Subject: Modification of the wing-fuselage connecting rods

Concerned: Sailplane Model: TCDS No. 315
 TWIN ASTIR S/N 3000 - 3291
 TWIN ASTIR TRAINER S/N 3000 - 3291 (with suffix "T")
 G 103 TWIN II S/N 3501 - 3729

Connector 103-2201/ 2202

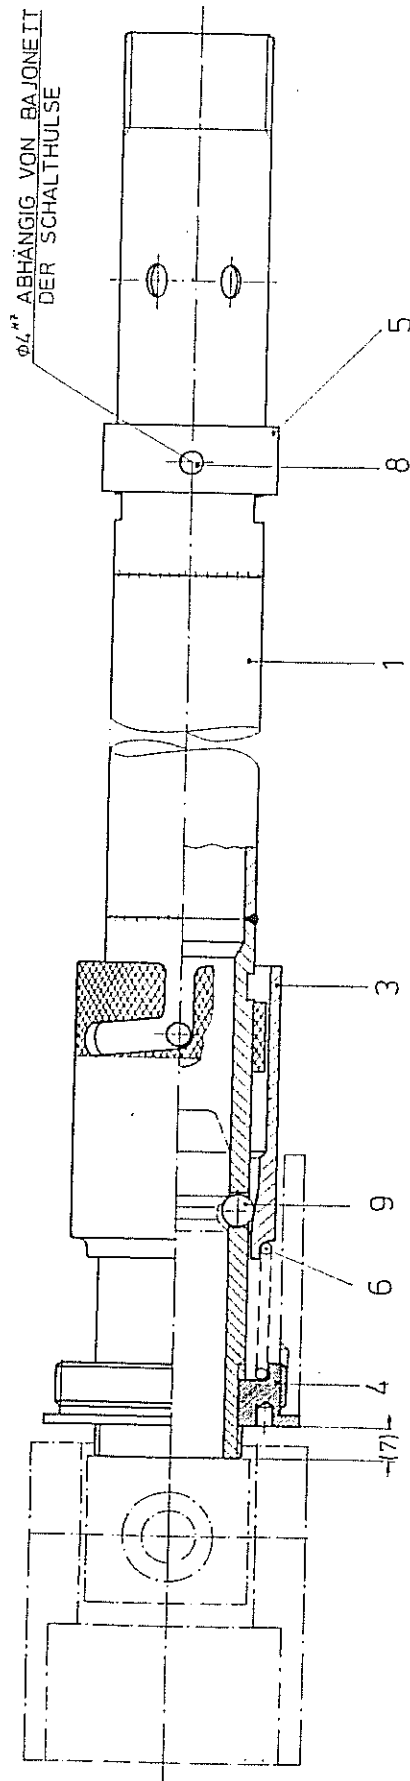
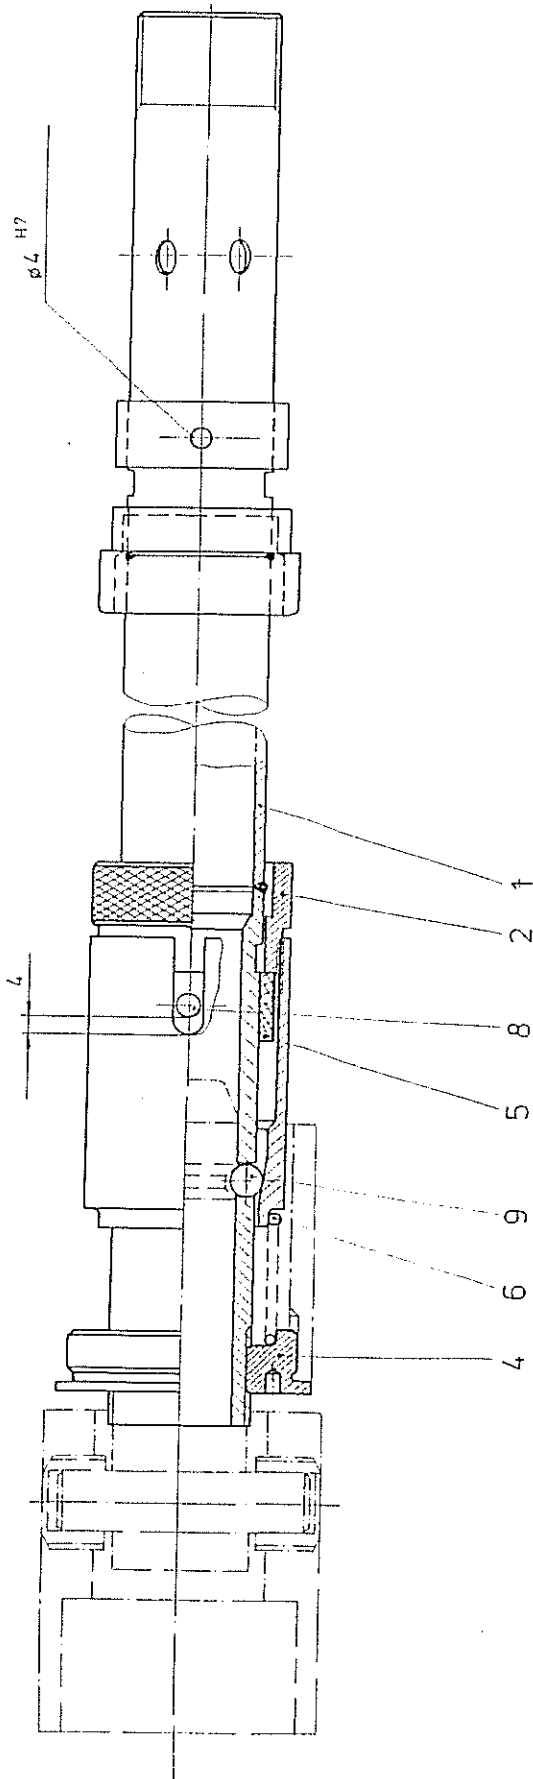
Procedure: Some parts of the wing-fuselage connecting rods P/N 103-2201/ 2202 are not manufactured any longer and so this parts can't be delivered as spares. Due to this fact the wing-fuselage connecting rods may be modified optionally during spares delivery or repair. This modification corresponds to the standard of the wing- fuselage connecting rods installed in the later glider models.

1. The modifications to the wing-fuselage connectors will be performed in accordance to the following drawings:

The following drawings will be substituted:

Connector 103-2201/ 2202/1			
Item	Qty.	Name	P/N
1	1	Connecting tube	103-2203
2	2	Knurled nut	109-2200.02
3	2	Socket	109-2201.03
4	2	Nut	103-2201.04
5	2	Ring	109-2201.05
6	2	Compression spring	103-2201.06
8	2	Pin	5m6x45 DIN 6325
9	12	Steel balls	$\phi 7$
